# KING'S MAPLE STREET SECOND ADDITION

## WICHITA, SEDGWICK COUNTY, KANSAS

RE: SUB 2000-43 -- Final Plat of King's Maple Street Second Addition

**CASE NUMBER:** SUB 2000-43 -- KING'S MAPLE STREET SECOND ADDITION

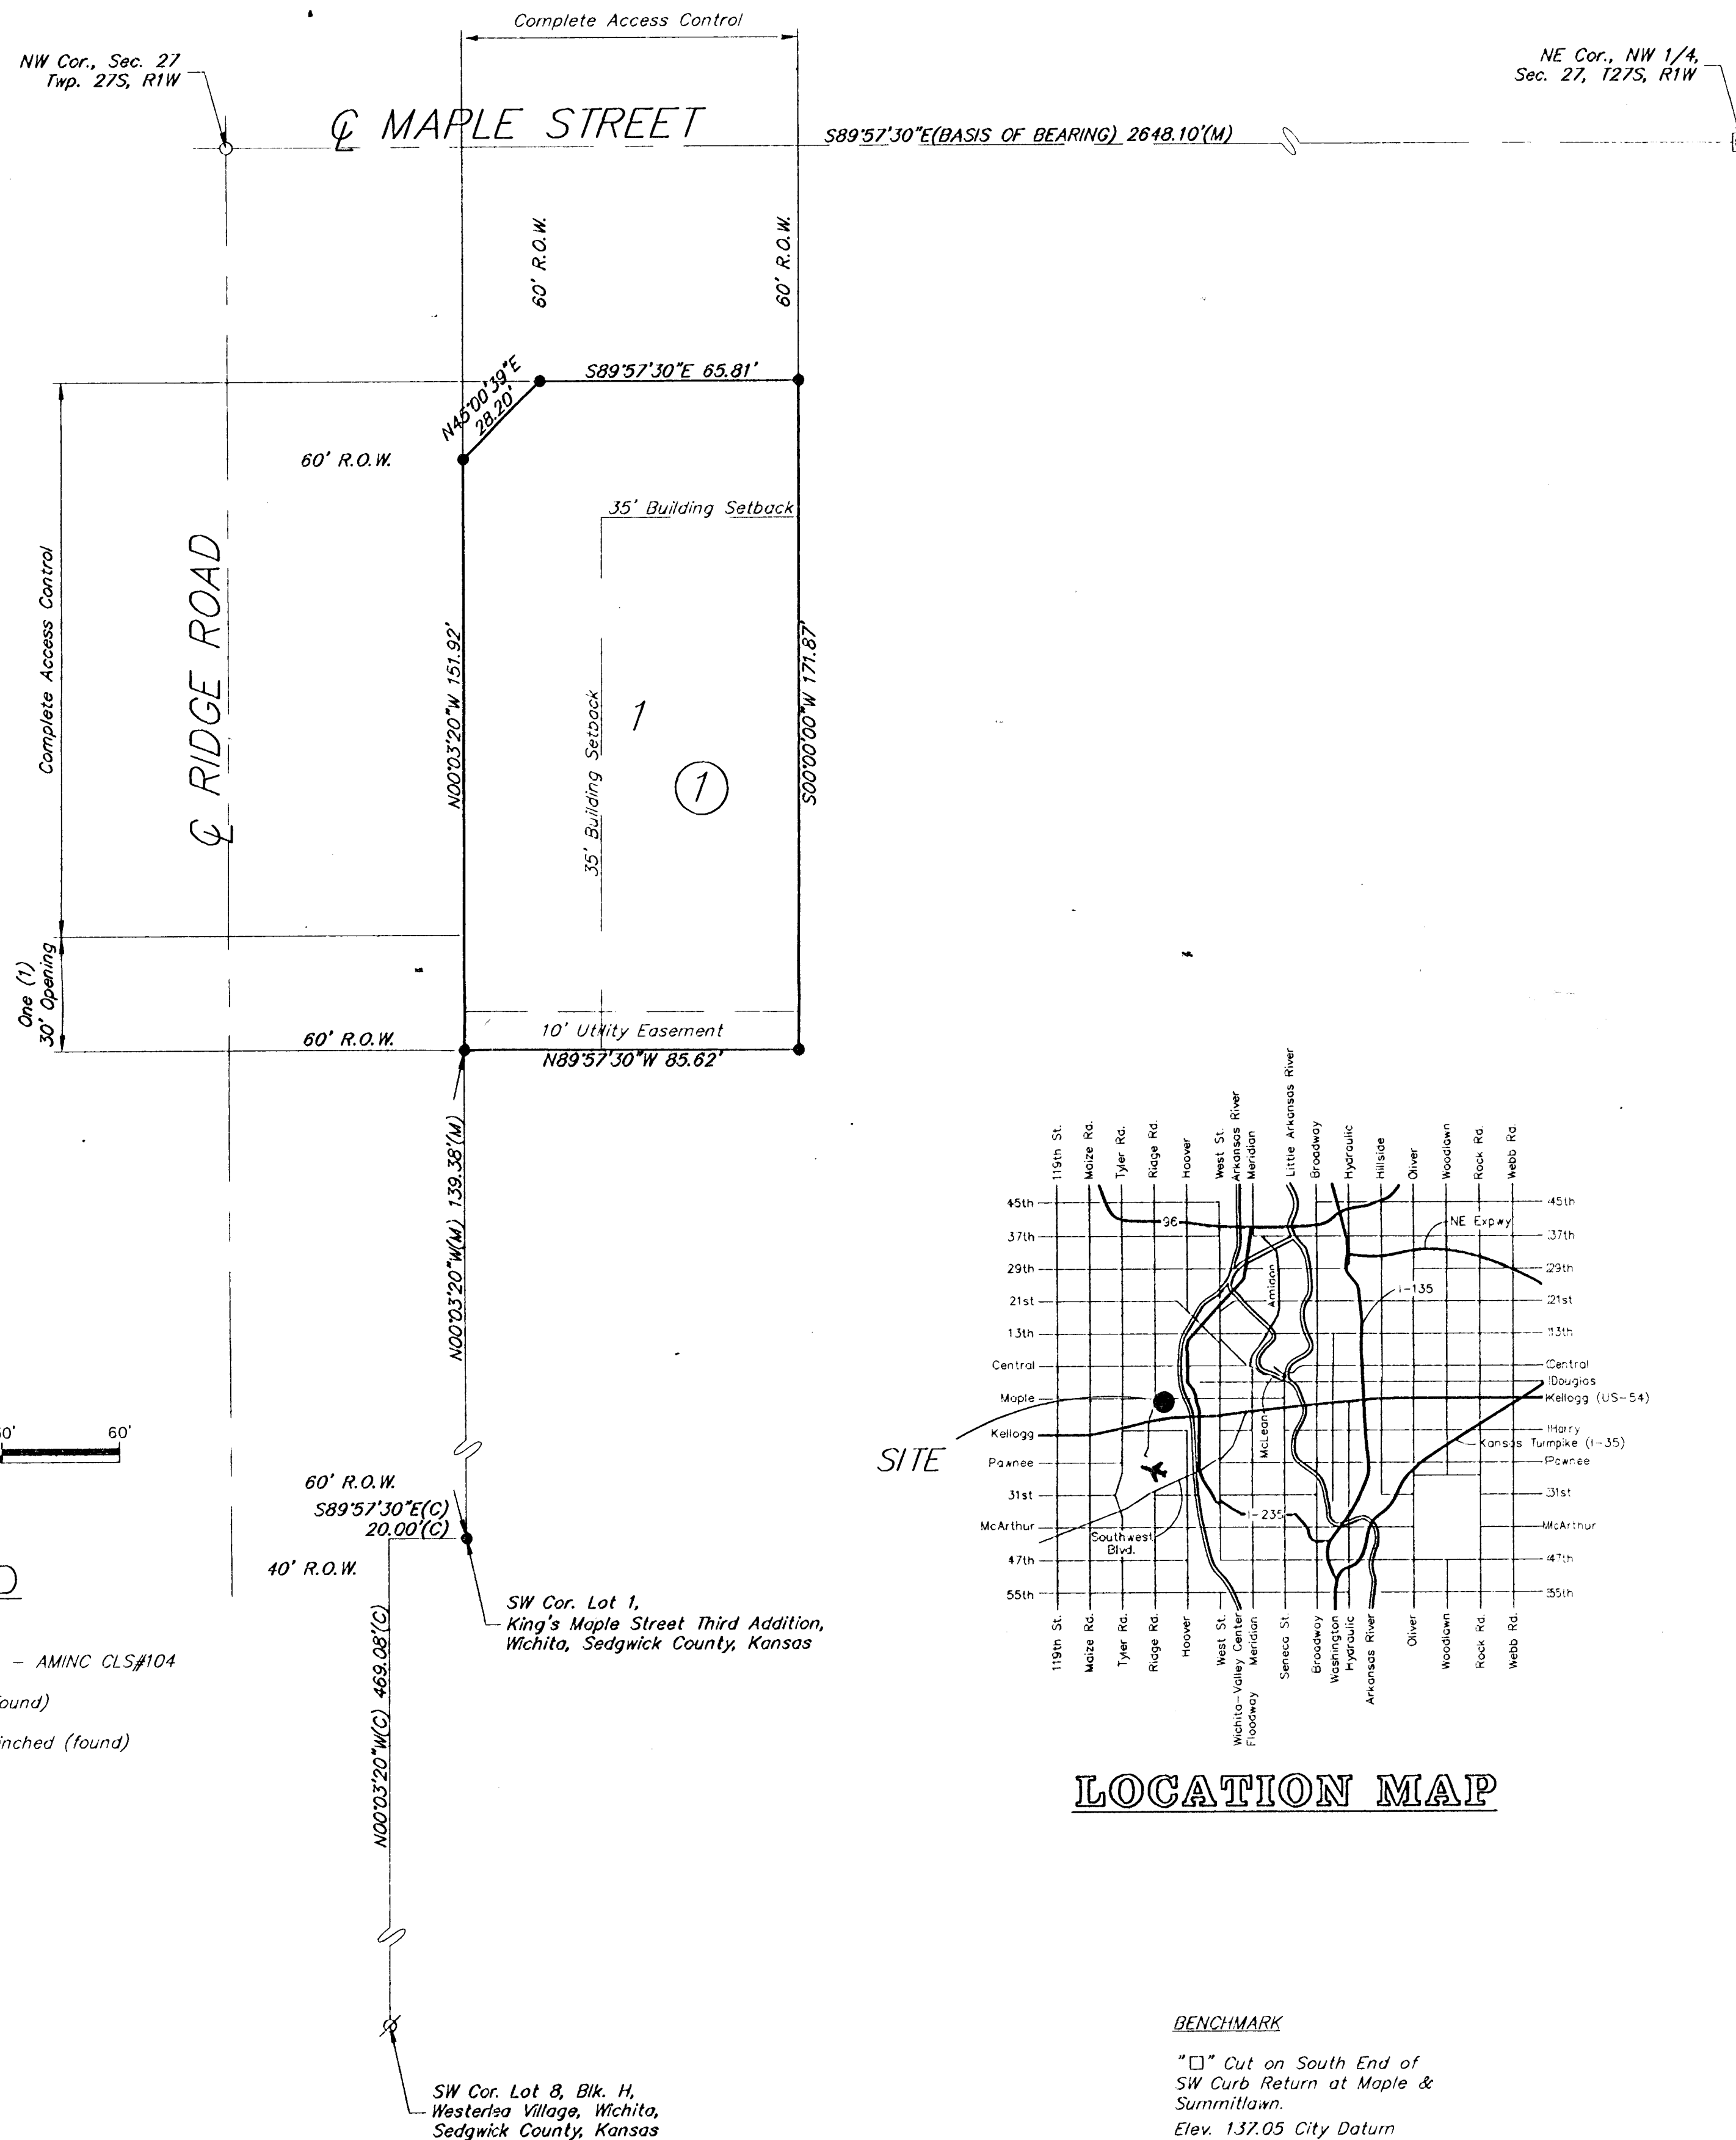
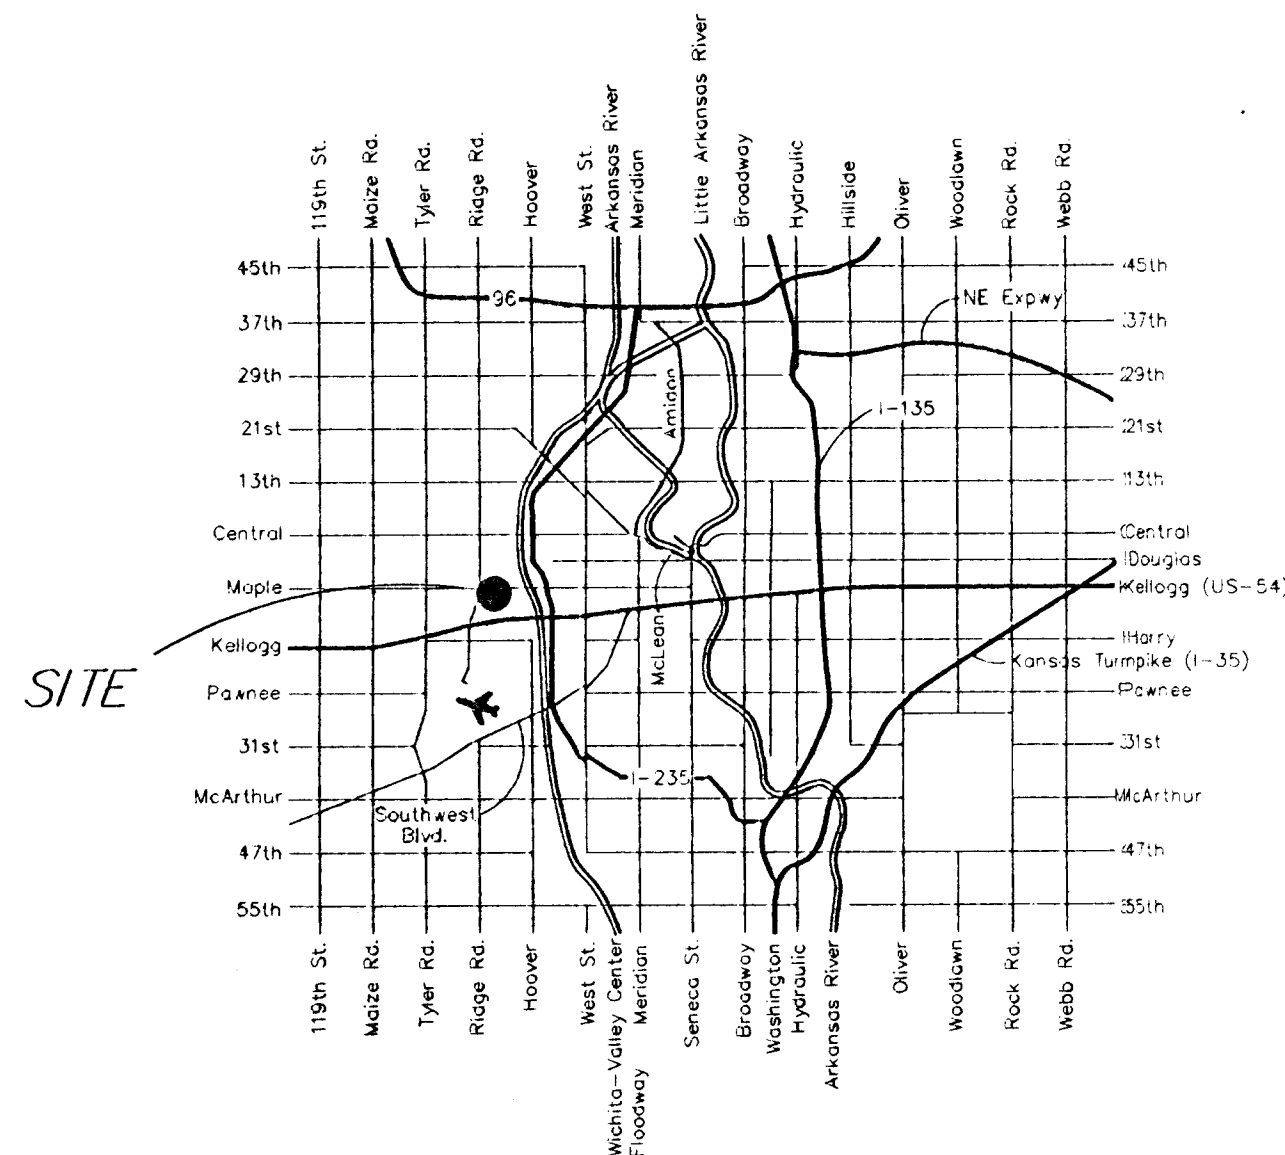
- C. **City Engineering** needs to comment on the status of the applicant's drainage plan. An off-site drainage agreement is needed.
- D. Dedication of access control except for one opening along the frontage of Ridge Road was required by Protective Overlay #63 associated with Z-3350; however this plat and the abutting plat to the south (King's Maple St. 3rd) indicates a total of two openings. MAPD recommends a joint opening be denoted along the south line of the plat and 150 feet of complete access control dedicated from the intersection. In accordance with the Subdivision regulations, any access openings located within 250 feet of the intersection of Maple and Ridge Road are limited to right-turns only, and shall be referenced on the face of the plat; or a guarantee provided for the future construction of a raised medial. The Subdivision Committee has approved a joint opening located along the south line of the plat.

- G. **Traffic Engineering** needs to comment on the need for the dedication of any additional right-of-way. The plat indicates a "corner clip" with a 60-ft half-street right-of-way in lieu of the standard 75-ft major street intersection. The street right-of-way is approved.

- M. On the final plat, the MAPC signature block needs to reference "J.D. Michaelis, Chair".
- N. The legal description needs to be corrected.
- O. The plattor's text shall include language that a drainage plan has been developed for the plat and that all drainage easements, rights-of-way, or reserves shall remain at established grades or as modified with the approval of the applicable City or County Engineer, and unobstructed to allow for the conveyance of stormwater.

A 5ft sidewalk easement within  
A 10ft utility easement is required  
(per Traffic Eng)

- W. The representatives from the utility companies should be prepared to comment on the need for any additional utility easements to be platted on this property. **Southwestern Bell has advised that overhead facilities are located within existing easements. Said easements need to be maintained, or the applicant shall pay costs to relocate the cables.**
